northern beaches council
PLANS APPROVED BY THE LAND AND ENVIRONMENT COURT OF NSW
PROCEEDINGS NO: 2023/238892
DATED: 5 June 2024

FOR S4.55 (8) APPLICATION

PROJECT:
PROPOSED SENIORS LIVING
4 ALEXANDER ST, COLLAROY
NSW

ROOF PLAN

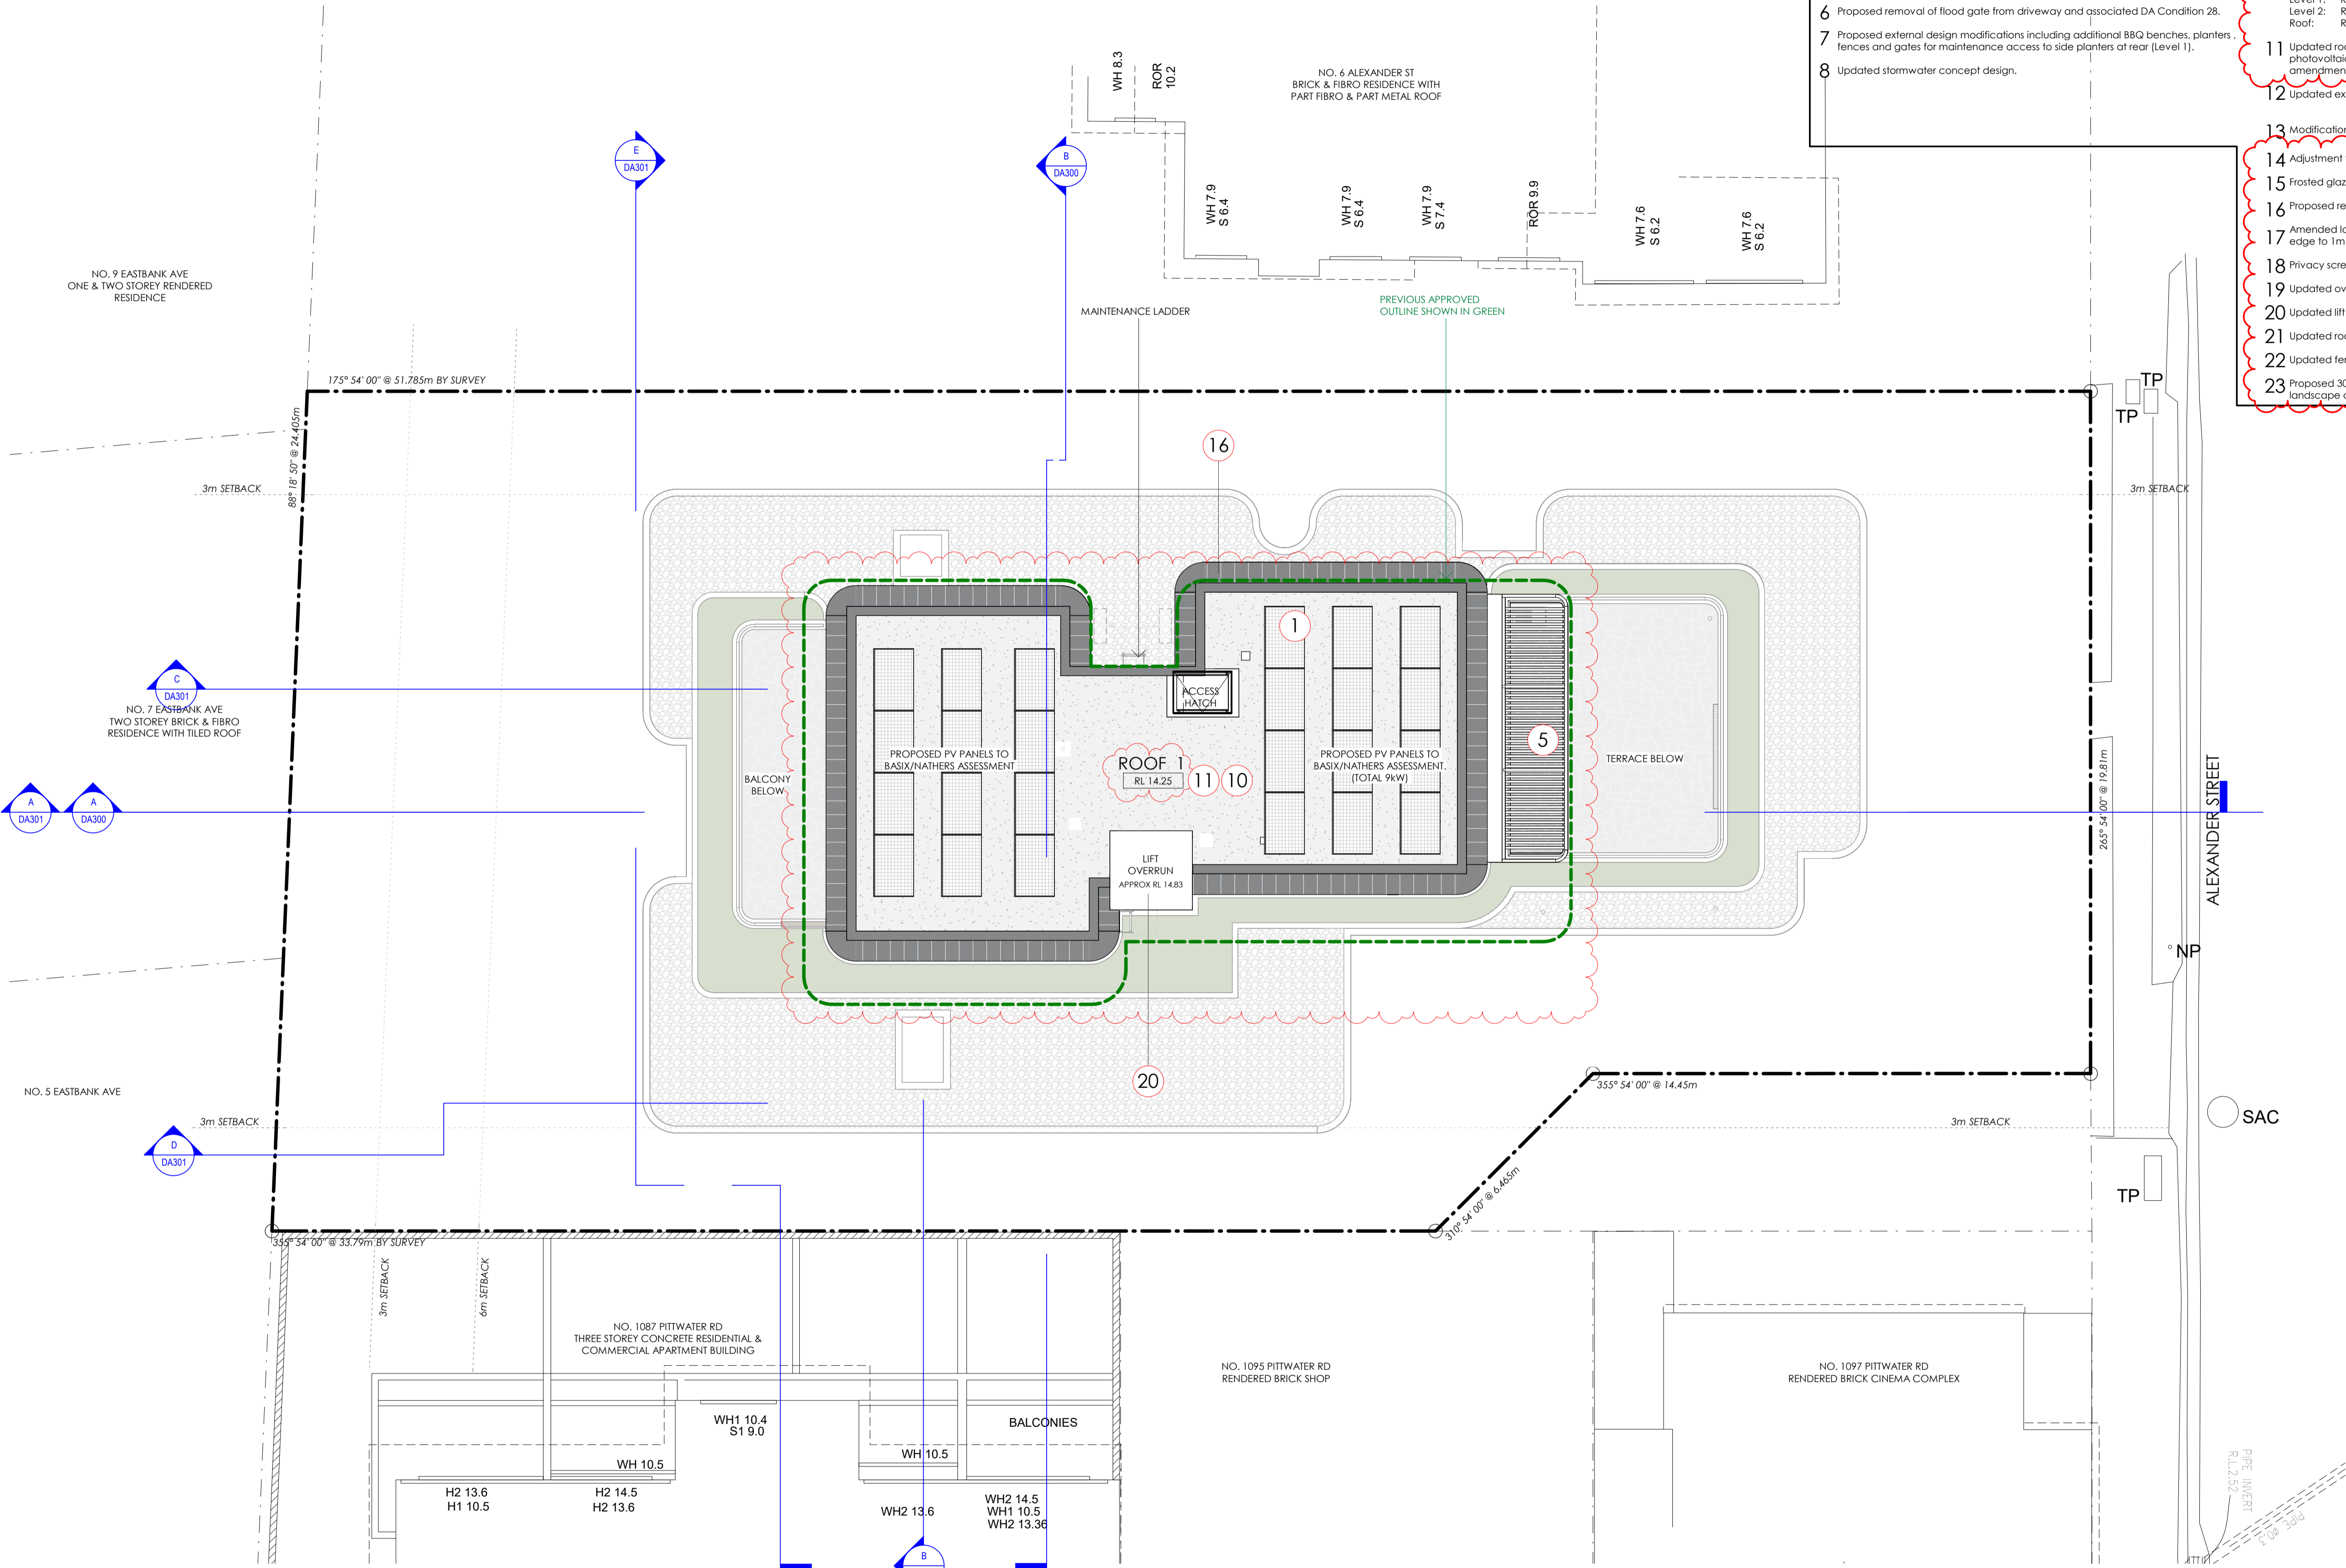
- 1 Proposed modifications to skylights including deletion of 2 skylights over unit 2.01, and updated sizes of skylights over Unit 1.02 & 1.03.
- 2 Additional storage room at basement level.

- 3 Updated interior layout generally.
- 4 Modification to facade windows openings and configurations generally.
- 5 Additional metal framed louvre awning to Level 2.

- 6 Proposed removal of flood gate from driveway and associated DA Condition 28.
- 7 Proposed external design modifications including additional BBQ benches, planters, fences and gates for maintenance access to side planters at rear (Level 1).

- 8 Updated stormwater concept design.
- 9 Associated landscape design update including:
a) Level 1: proposed updated overland flow path based on civil eng.'s assessment

b) Level 1: proposed 2 additional private plunge pools at rear
c) Level 1: Revised boundary fencing height and design at rear
d) Level 1: Revised external levels

e) Level 1: Revised external backyard
f) Ground floor: Revised front garden design to G.01 and around OSD tank area
- 10 Proposed building height increase including adjustments to floor levels to:
Level 1: RL 7.73
Level 2: RL 11.03
Roof: RL 14.25

- 11 Updated roof layout including adjustment to lift overrun structure, services layout and photovoltaic panels. Proposed deletion of DA Condition 8 as part of the proposed amendments at roof level.

- 12 Updated extent of shoring and retention generally.
- 13 Modification to proposed car parking arrangement and number of car space.
- 14 Adjustment to level 2 envelope shifting towards west generally.

- 15 Frosted glazing to level 2 ensuite window
- 16 Proposed removal of topmost roof overhang and revision to the perimeter parapet detail.
- 17 Amended landscape design at level 2 including additional planters and increase southern edge to 1m width.

- 18 Privacy screen to eastern edge of level 2 balcony at rear.
- 19 Updated overland flow path design.
- 20 Updated lift overrun level.
- 21 Updated roof layout to relocate AC units to lower levels.

- 22 Updated fence height to southern boundary
- 23 Proposed 300mm shoring wall setback from boundary with additional planters to landscape architect's details

DA201
ELEVATIONS 02

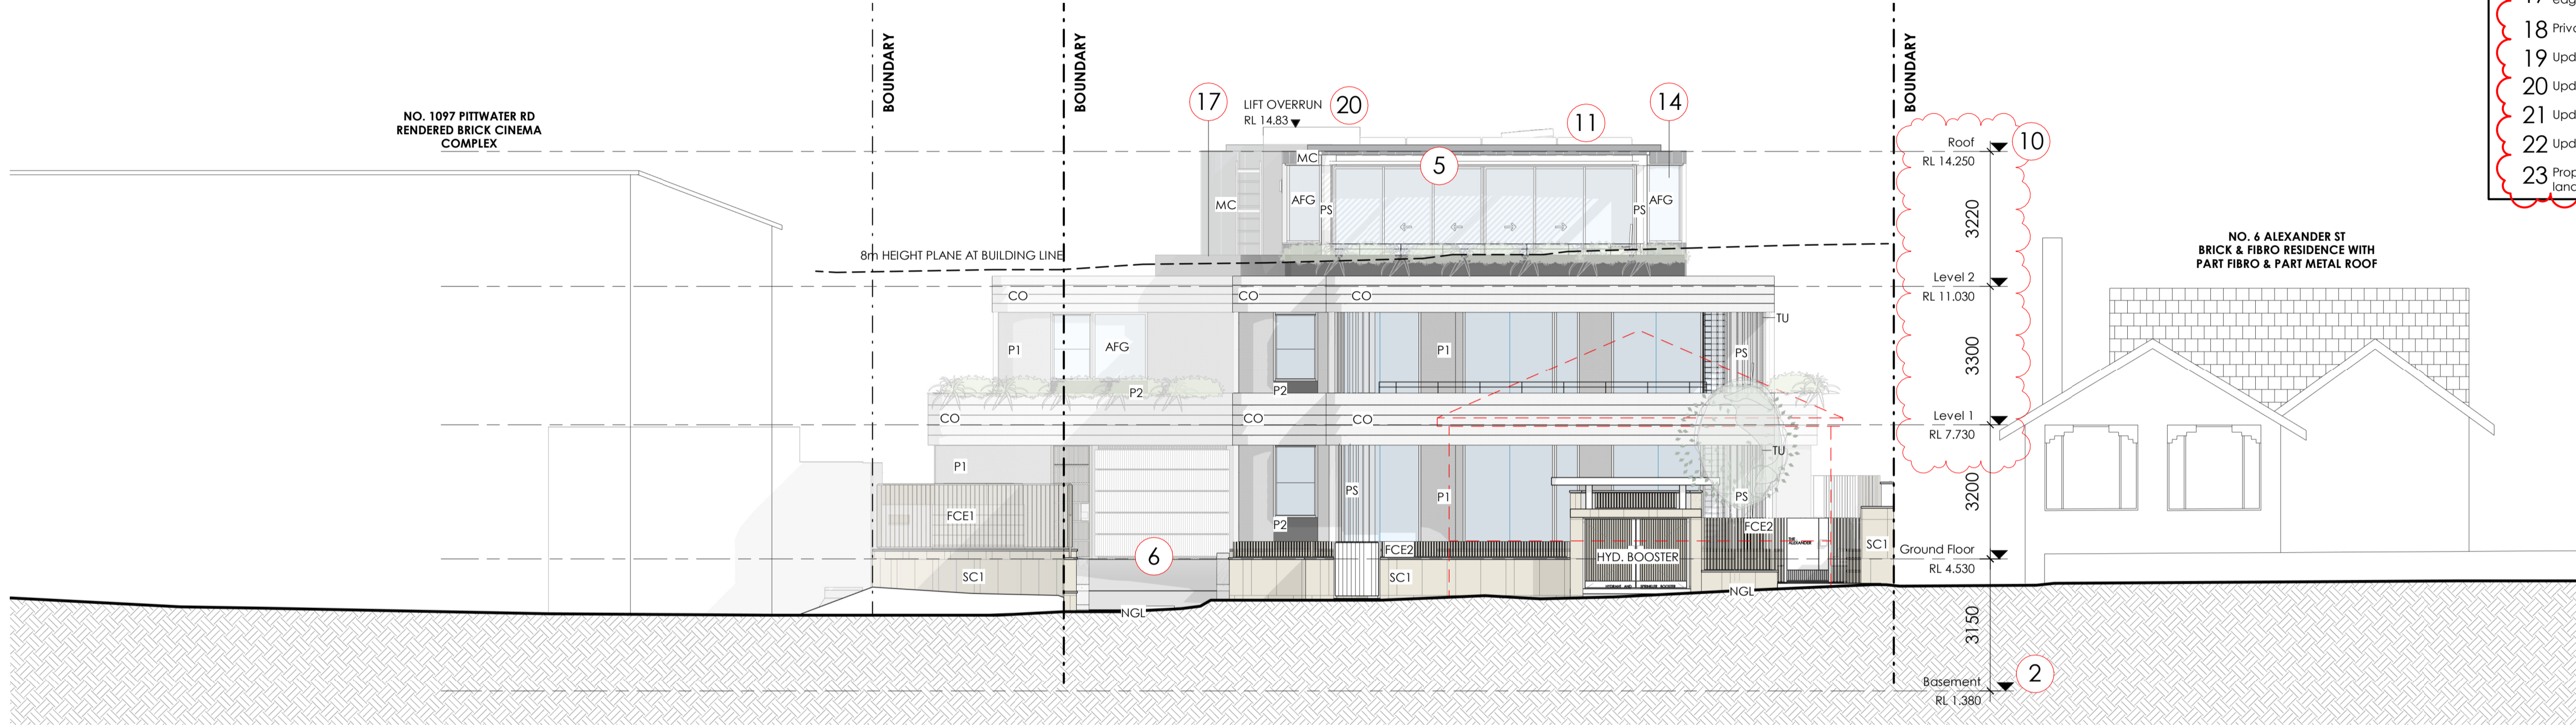
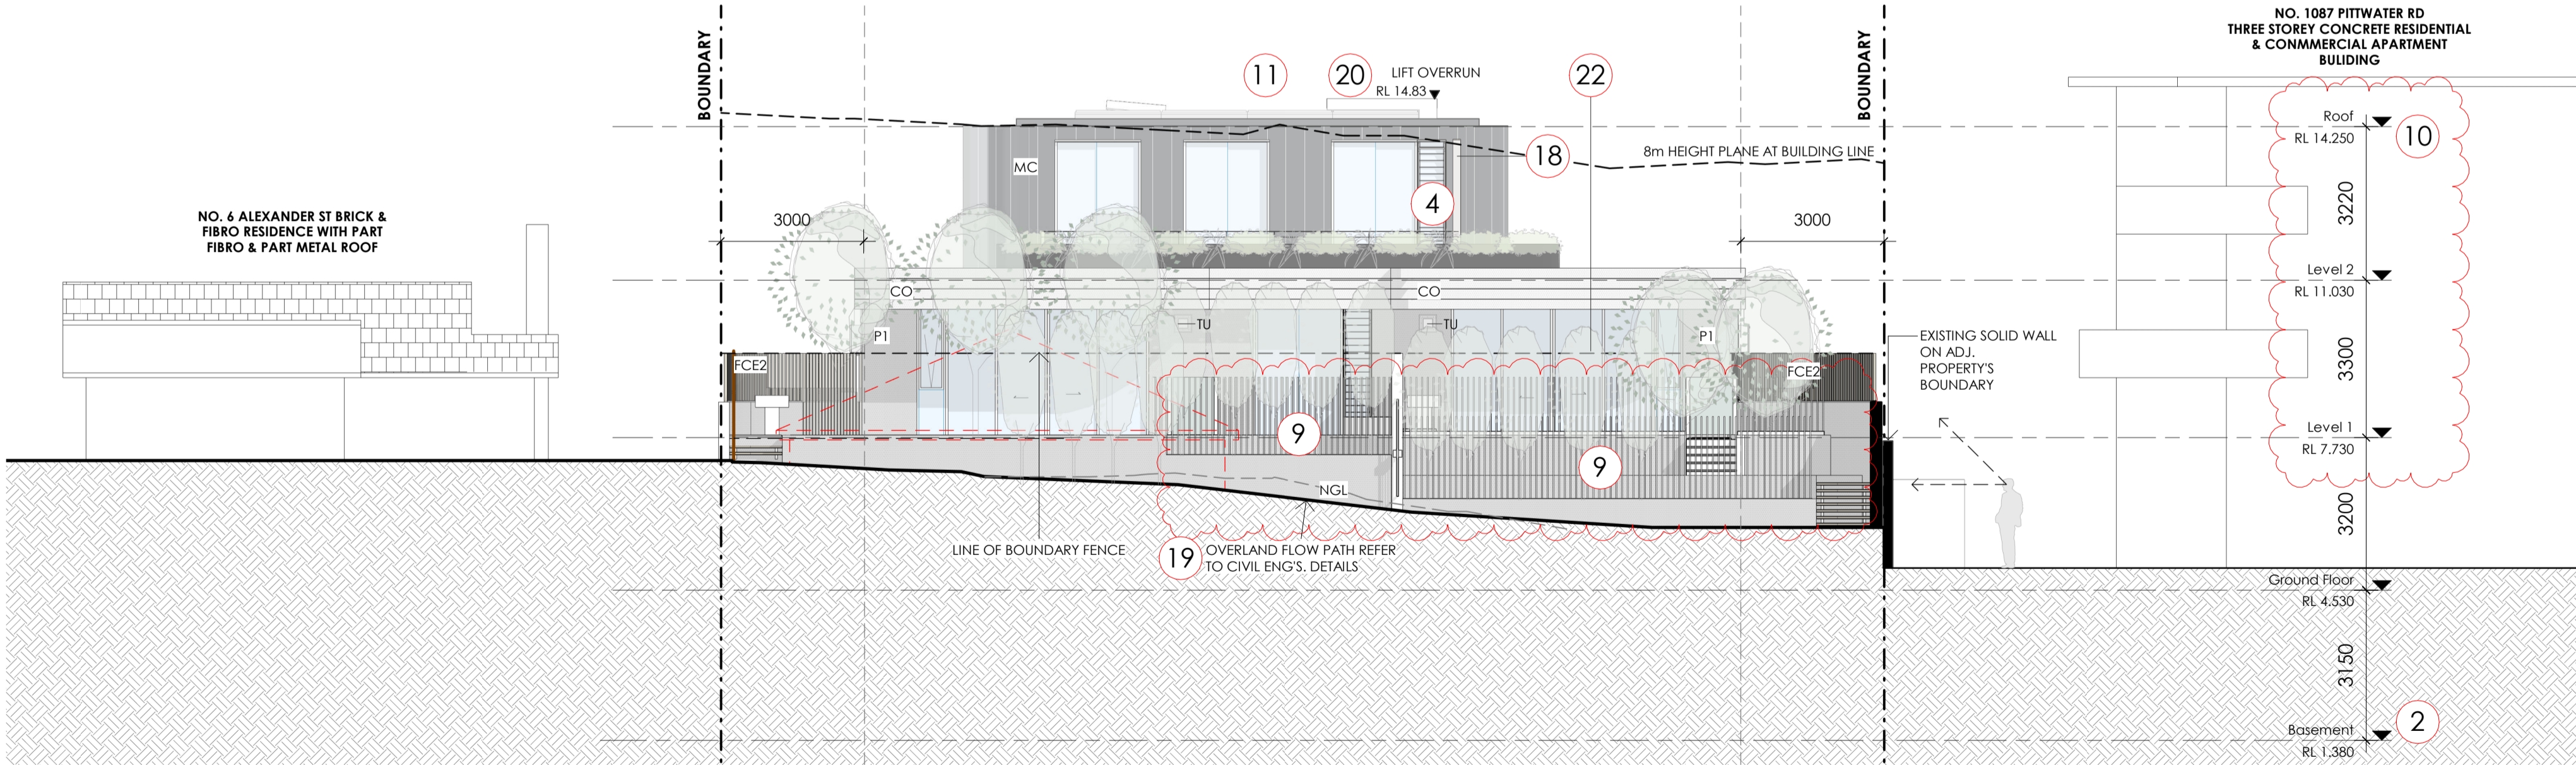
- PROPOSED MODIFICATION ITEM NO. REFER TO LIST BELOW
- Proposed modifications to skylights including deletion of 2 skylights over unit 2.01, and updated sizes of skylights over Unit 1.02 & 1.03.

- Additional storage room at basement level.
- Updated interior layout generally.
- Modification to facade windows openings and configurations generally.

- Additional metal framed louvre awning to Level 2.
- Proposed removal of flood gate from driveway and associated DA Condition 28.
- Proposed external design modifications including additional BBQ benches, planters, fences and gates for maintenance access to side planters at rear (Level 1).

- Updated stormwater concept design.
- Associated landscape design update including:
 - a) Level 1: proposed updated overland flow path based on civil eng.'s assessment

- b) Level 1: proposed 2 additional private plunge pools at rear
 - c) Level 1: Revised boundary fencing height and design at rear
 - d) Level 1: Revised external levels

- e) Level 1: Revised external backyard
 - f) Ground floor: Revised front garden design to G.01 and around OSD tank area
- Proposed building height increase including adjustments to floor levels to:

- Level 1: RL 7.73
 - Level 2: RL 11.03
 - Roof: RL 14.25
- Updated roof layout including adjustment to lift overrun structure, services layout and photovoltaic panels. Proposed deletion of DA Condition 8 as part of the proposed amendments at roof level.

- Updated extent of shoring and retention generally.
- Modification to proposed car parking arrangement and number of car space.
- Adjustment to level 2 envelope shifting towards west generally.

- Frosted glazing to level 2 ensuite window
- Proposed removal of topmost roof overhang and revision to the perimeter parapet detail.
- Amended landscape design at level 2 including additional planters and increase southern edge to 1m width.

- Privacy screen to eastern edge of level 2 balcony at rear.
- Updated overland flow path design.
- Updated lift overrun level.
- Updated roof layout to relocate AC units to lower levels.

- Updated fence height to southern boundary
- Proposed 300mm shoring wall setback from boundary with additional planters to landscape architect's details
